RIDGE PORT 3RD ADDITION

RE: S/D 99-84 -- Final Plat of RIDGE PORT 3RD ADDITION

RE: S/D 99-84 -- Final Plat of RIDGE PORT 3RD ADDITION

CASE NUMBER: S/D 99-84 -- RIDGE PORT 3RD ADDITION

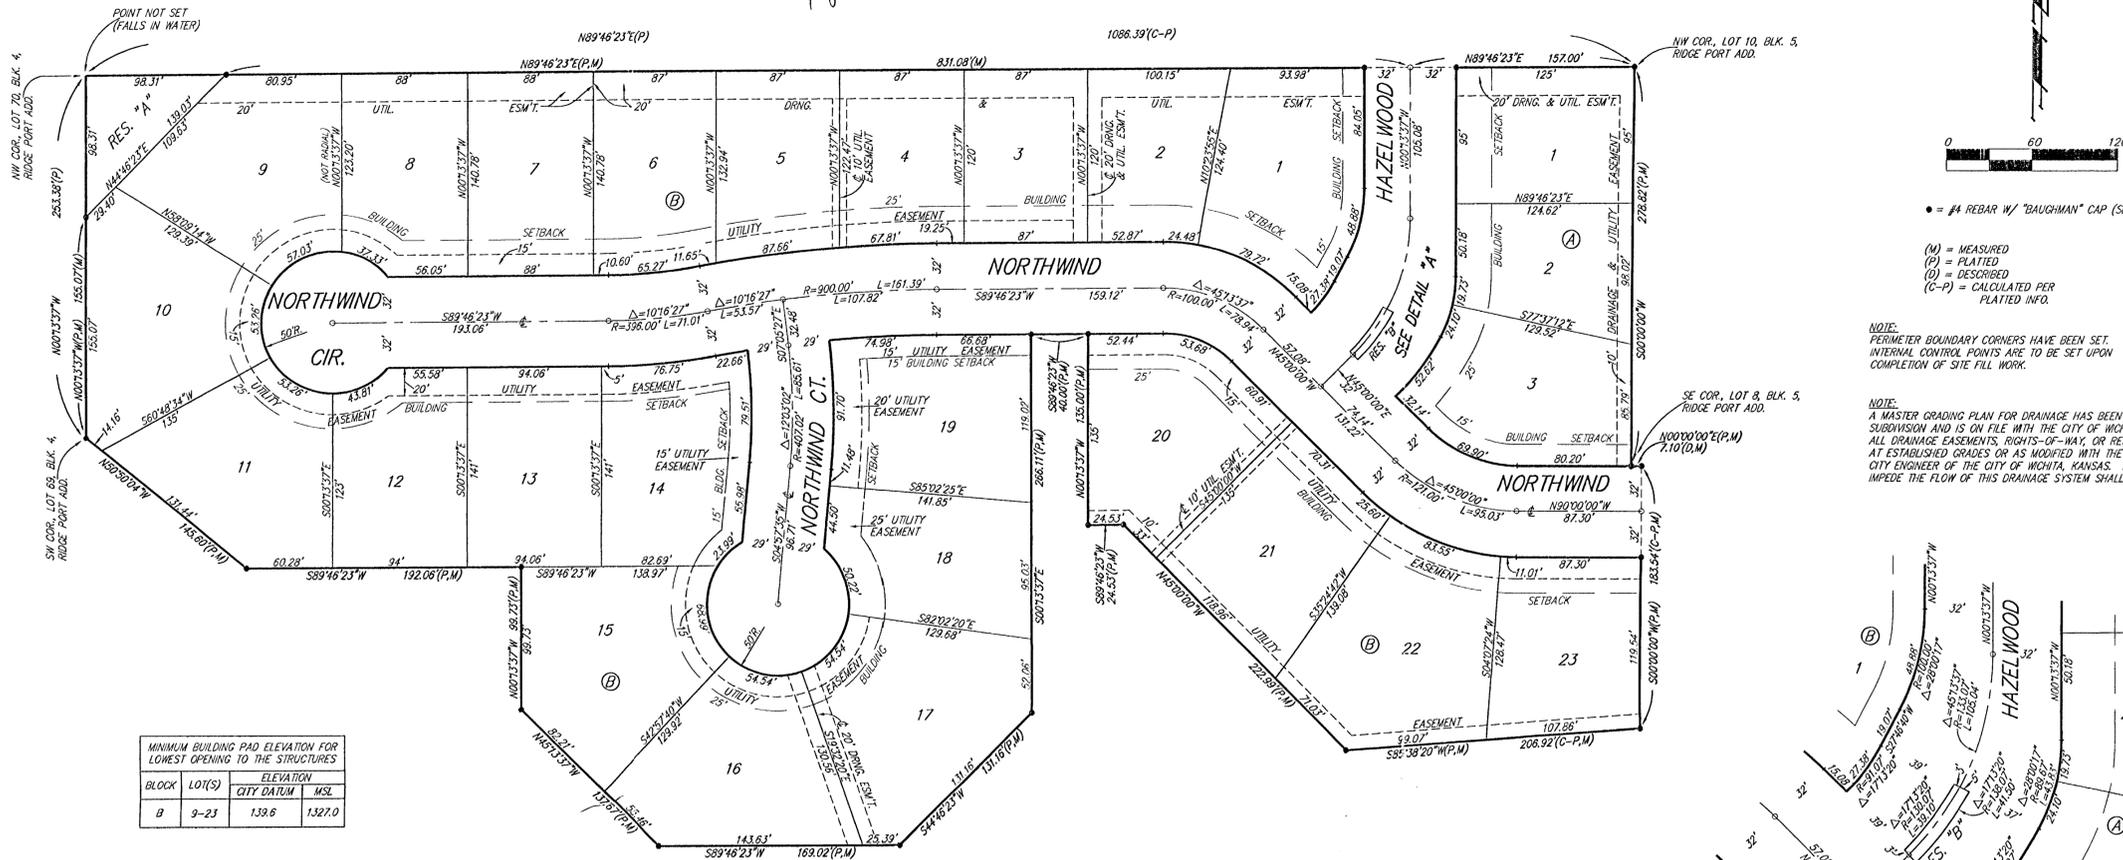
- I. City Fire Department should comment on the length of the interior streets. Northwind (680 ft) exceeds the 600-ft limitation on street length. *City Fire has approved the length of this street due to its 64 foot width.*

- F. City Fire Department needs to comment on the plat's street names. *The final plat tracing needs to indicate the following street name changes: Northwind Court to Northwind Circle, Northwind Circle to Northwind Court.*

The final plat has made the requested street name changes.
